2020 Corvette: Recall Notice: #N202309350: Non-Compliance - Interior Trunk Release Button Inoperative Ten Minutes After Power Off

Subject: N202309350 — Interior Trunk
Release Button Inoperative Ten
Minutes After Power Off

Models: 2020 Chevrolet Corvette

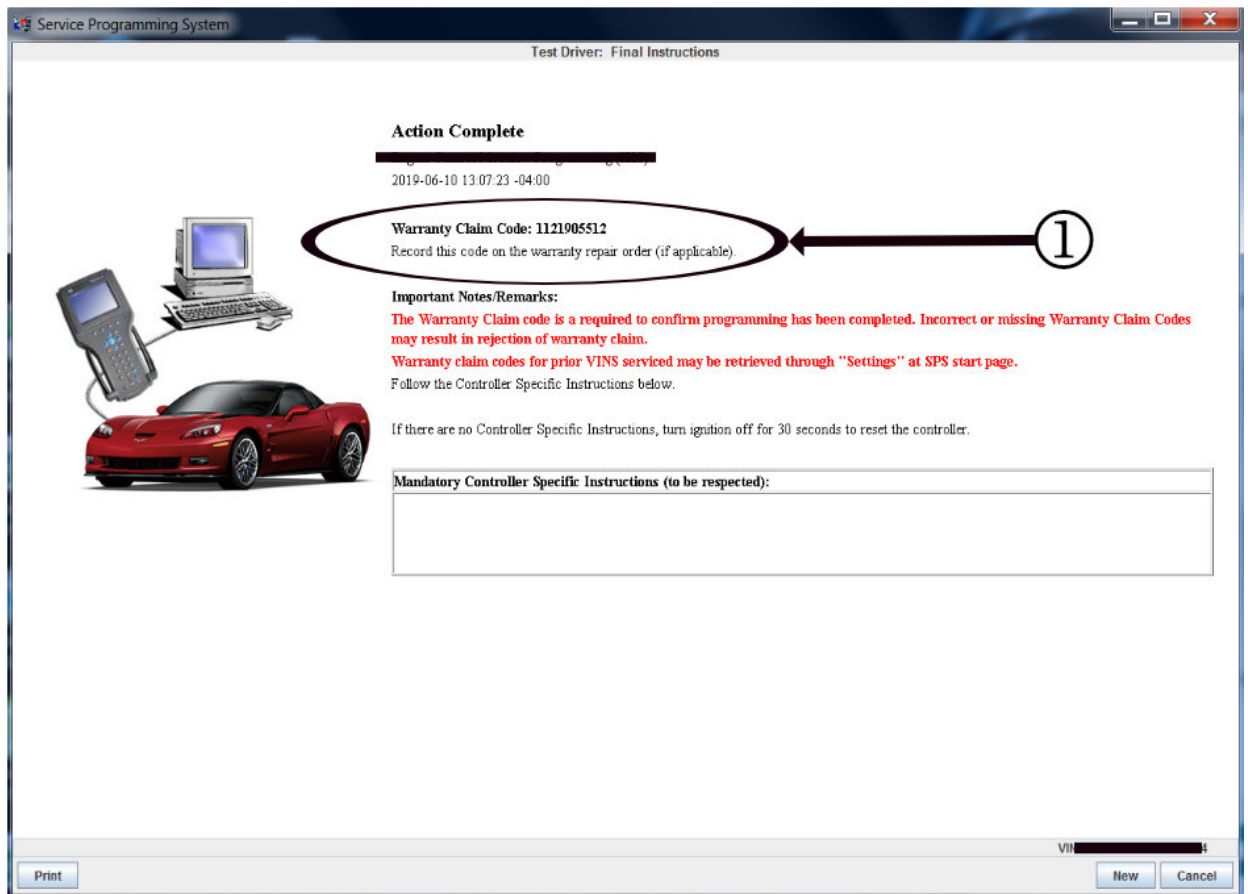
1. Reprogram the body control module. Refer to *K9 Body Control Module: Programming and Setup* in SI.

claim code provided on the SPS Warranty Claim Code (WCC) screen on the job card. Refer to callout 1 for the location of the WCC on the SPS screen.

1. Record SPS Warranty Claim Code on job card for warranty transaction submission.
